# Access Compliance Report

## Public Rights-of-Way

Intersection ID: 10942	Main Street: S_I-77_EXIT_10B_RA	Cross Street: W_5TH_ST	Location: E
ADA ID: 255BEC0EEB4D	Ramp Type: PerpDiag	Initial Pass/Fail: Fail	Overall Compliance: No
Severity Score: 8.75			
Codes/Mitigation Info/Possible Solution		Field Measurements/Component Compliance

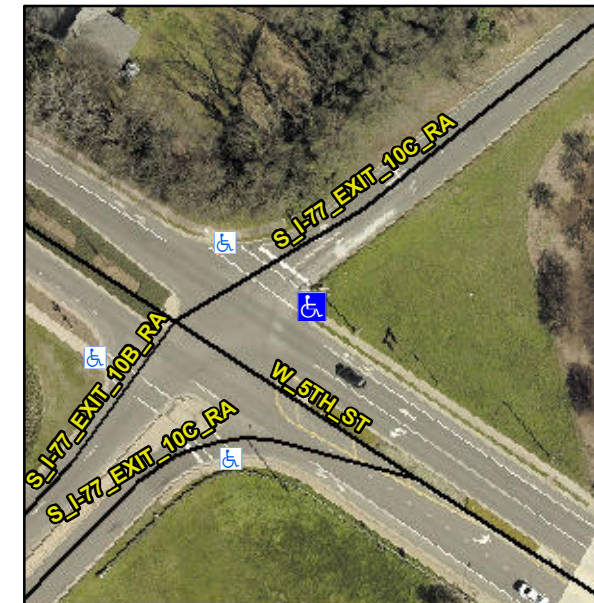
**Not Found, R304.5.1**

Compliance	Description	Data	Compliance	Description	Data
N/A	Ramp Length (in)	78.0	Yes	Ramp Slope (%)	5.2
No	Ramp Width (in)	47.5	Yes	Ramp XSlope (%)	0.8
N/A	Flare Type LT	N/A	N/A	Flare Type RT	N/A
N/A	Flare Slope LT (%)	N/A	N/A	Flare Slope RT (%)	N/A
N/A	Flare Traversable LT?	N/A	N/A	Flare Traversable RT?	N/A
N/A	Landing Length (in)	N/A	N/A	DWS Provided?	N/A
N/A	Landing Width (in)	N/A	N/A	DWS Contrast?	N/A
N/A	Landing Slope (%)	N/A	N/A	DWS Length (in)	N/A
N/A	Landing X Slope (%)	N/A	N/A	DWS Full Width?	N/A
N/A	Landing Curb? (Y/N)	N/A	N/A	DWS Offset (in)	N/A
N/A	Shared Landing?	N/A			
N/A	Gutter Ponding?	N/A	N/A	Gutter Slope (%)	N/A
N/A	Gutter Lip Ht (in)	0.5	N/A	Gutter X Slope (%)	N/A
N/A	Painted X Walk1?	Yes	N/A	Painted X Walk2?	No
	X Walk 1 Direction	To NW		X Walk 2 Direction	To SW
N/A	X Walk 1 Width (in)	110.0	N/A	X Walk 2 Width (in)	N/A
	X Walk 1 Slope (%)	3.6		X Walk 2 Slope (%)	4.3
	X Walk 1 X Slope (%)	2.1		X Walk 2 X Slope (%)	2.0

**Remove & Replace Curb Ramp With Two New Directional Ramps or Equivalent.**
